Office Action Summary	Application No. 10/590,461	Applicant(s) MACDOUGALL, JOHN	
	Examiner Troy Chambers	Art Unit 3641

DETAILED ACTION

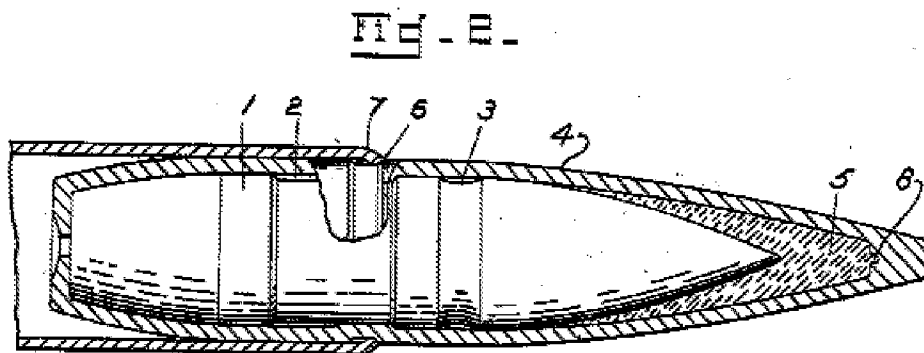
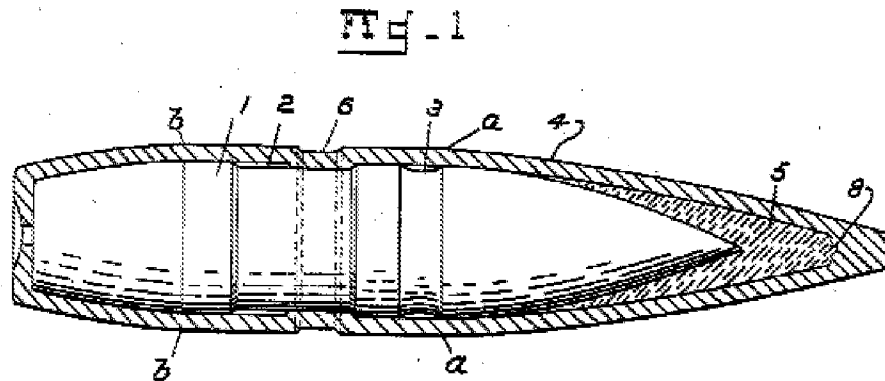
2. Claims 1-5, 8, 10, 11, 14, 15 and 23 are rejected under 35 U.S.C. 102(b) as being anticipated by US 2322751 issued to Studler.

3. With respect to claim 1, Studler discloses a projectile having an engravable jacket 4; and a central cylindrical core 1 having an annular grooves 2, 3 at its "midsection portion". The grooves 2, 3 discontinue contact between the core 1 and the

jacket 4 at those locations. The midsection grooves taper toward both ends of the projectile.

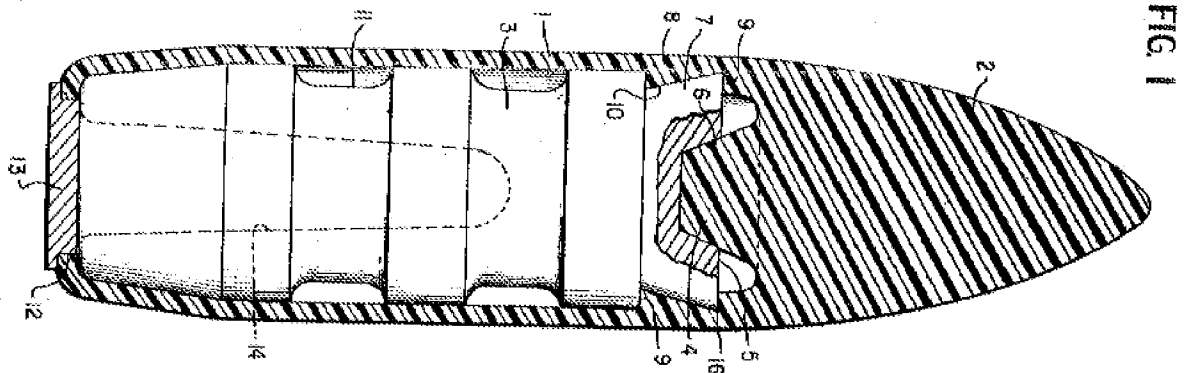
4. With respect to claims 2-4, the gap formed by the tapered grooves 2, 3 fully encircle the core 1 and form a space between said jacket 4 and said core.

5. With respect to claim 5, the midsection tapers and is therefore frustoconical in shape.

6. With respect to claims 10 and 11, the grooves 2, 3 are comprised of empty space and therefore occupied by air.

7. With respect to claim 14, Figures 1 and 2 show the core 1 having an ogival shape. The junction between the forward and the midsection provides a "smooth" transition zone.

8. With respect to claim 15, Figures 1 and 3 appear to show the rear of the core 1 tapering inward.
